AGENDA
MILWAUKIE PLANNING COMMISSION
Tuesday, June 13, 2017, 6:30 PM

5.4 Summary: Railroad Ave Subdivision

File: S-2017-002, VR-2017-001, VR-2017-006, ZA-2017-002, CPA-2017-001

PRELIMINARY SUBDIVISION PLANS FOR KEIL GARDENS SUBDIVISION

SHEET TITLE:
COVER SHEET
 G-0.01

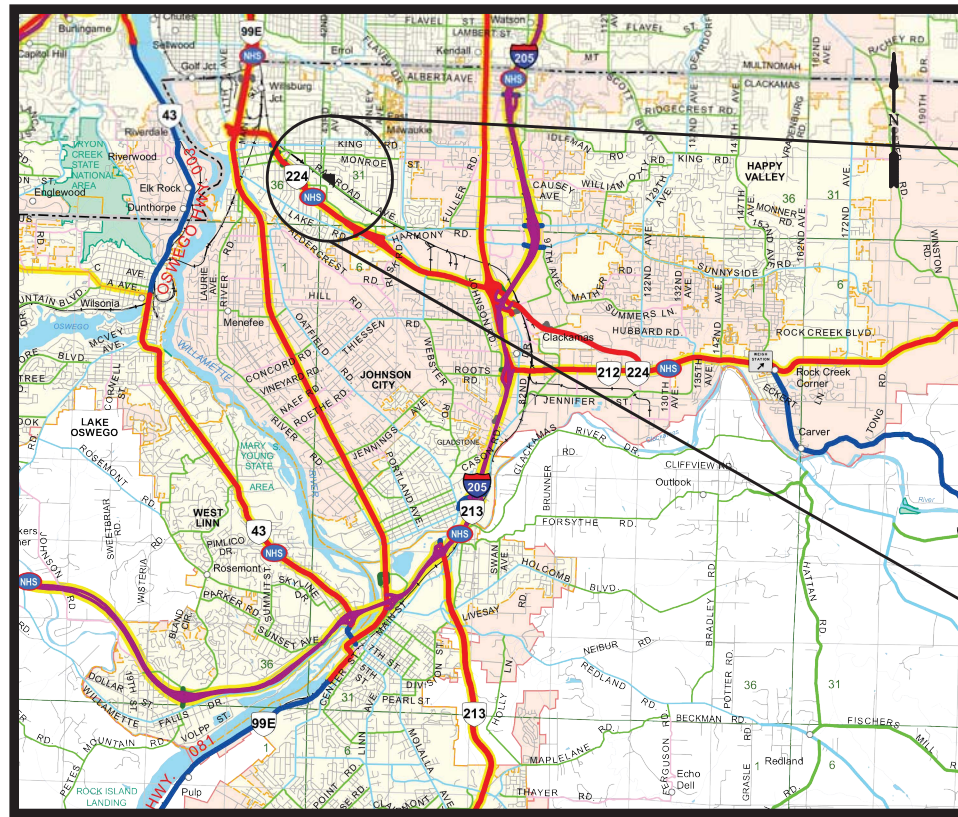
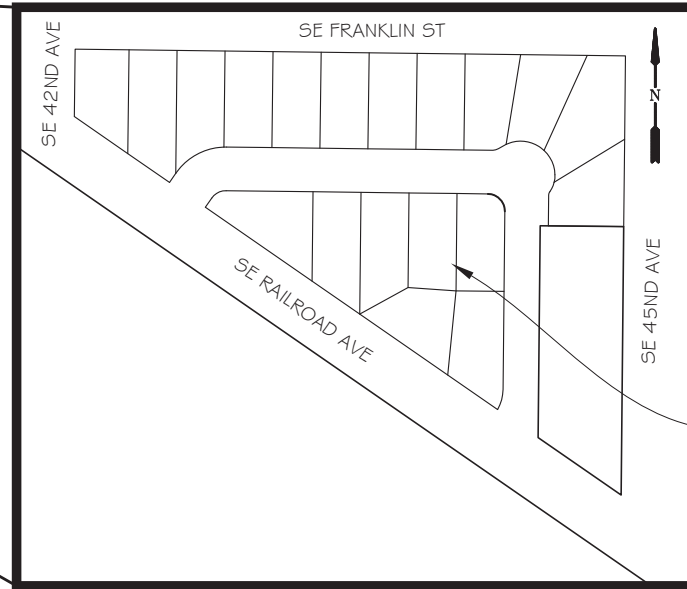
- a. Sheet G-0.01 of the submitted plan set denotes a different property owner than the owner listed on page 1 of the application narrative. Please revise the submittal so that this information is correct and consistent within the application sections.

HORIZ DATUM: LOCAL	VERT SCALE: AS SHOWN	DRAWN: JBL	DESIGN: JDL	APPROVED: JDL
SHEET TITLE:				
SITE PLAN				
C-1.03

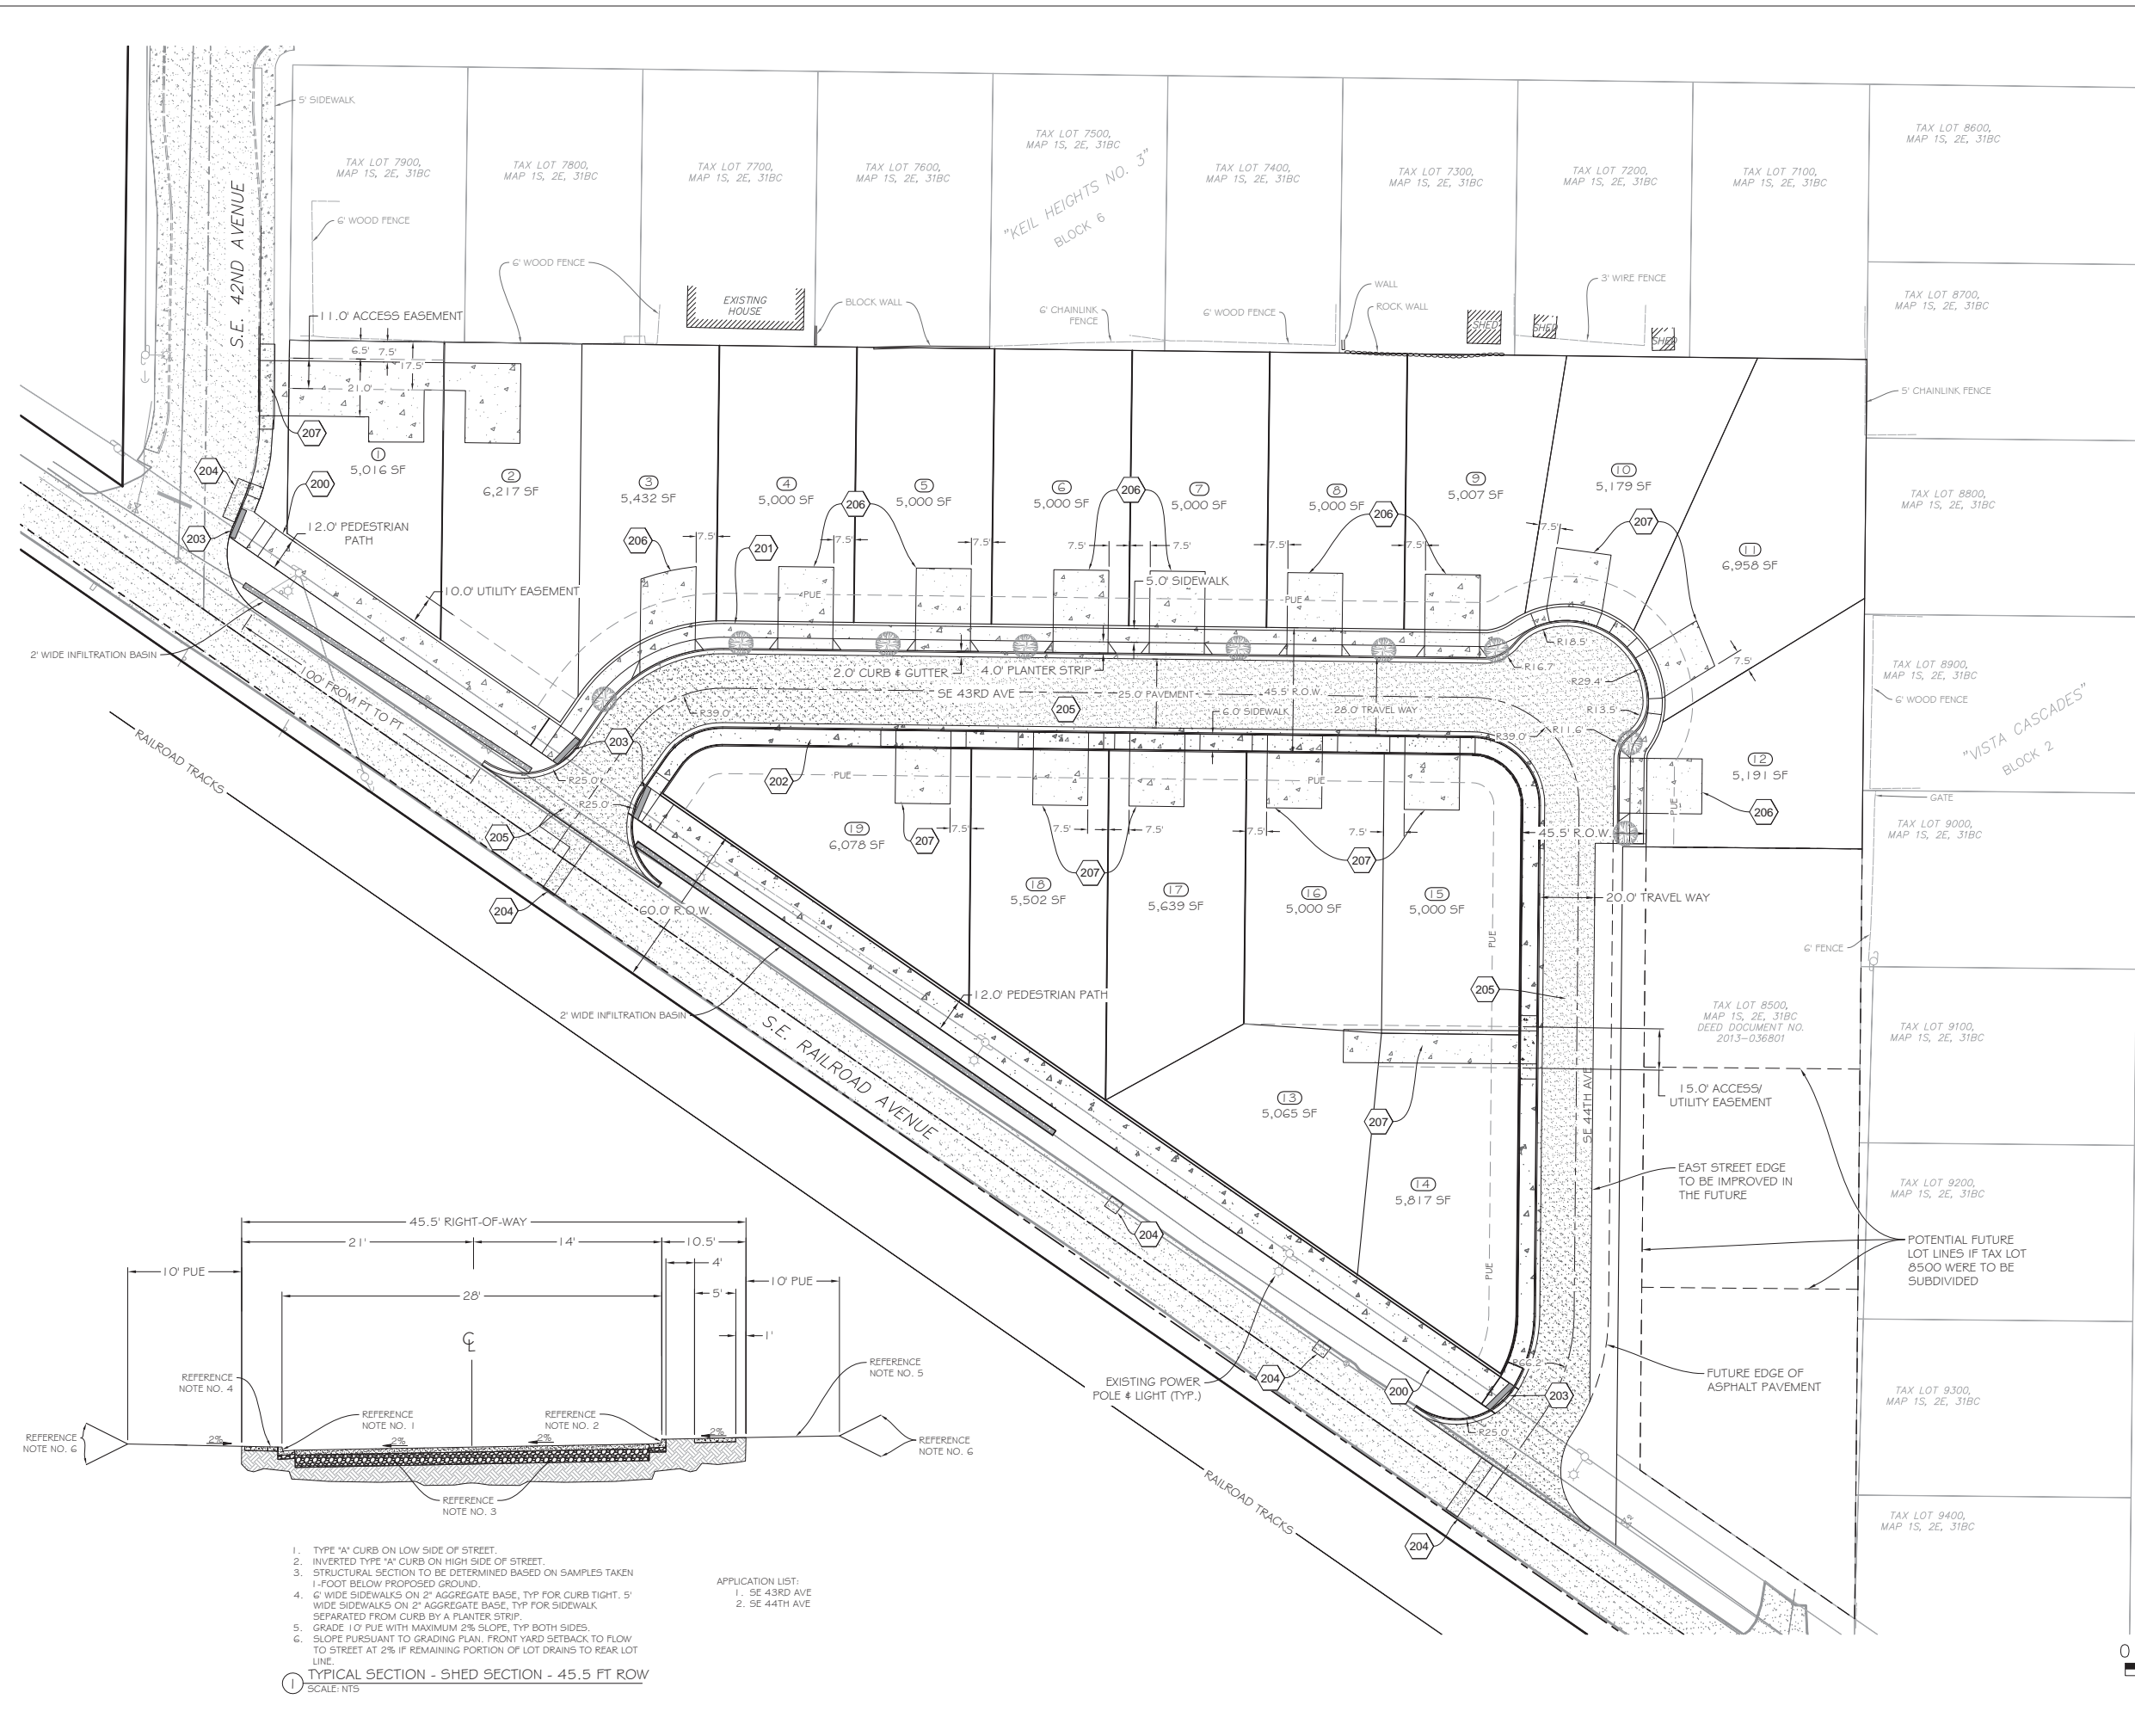
c. As defined in MMC 17.28.040.F, required frontage shall be measured along the street upon which the lot takes access. As shown on Sheet C-1.03, Lot 1, Lot 2, and Lot 13 show access via an

5. Plan Sheet C-1.03 indicates a right-of-way width of 45.5 ft. The sum of the components shown should be 48 ft.

Comment: The proposed internal street is 28-feet (curb to curb) There is a cross section detail on Sheet C1.03. the 2/3rds street on the east side of the property will be 21-feet.
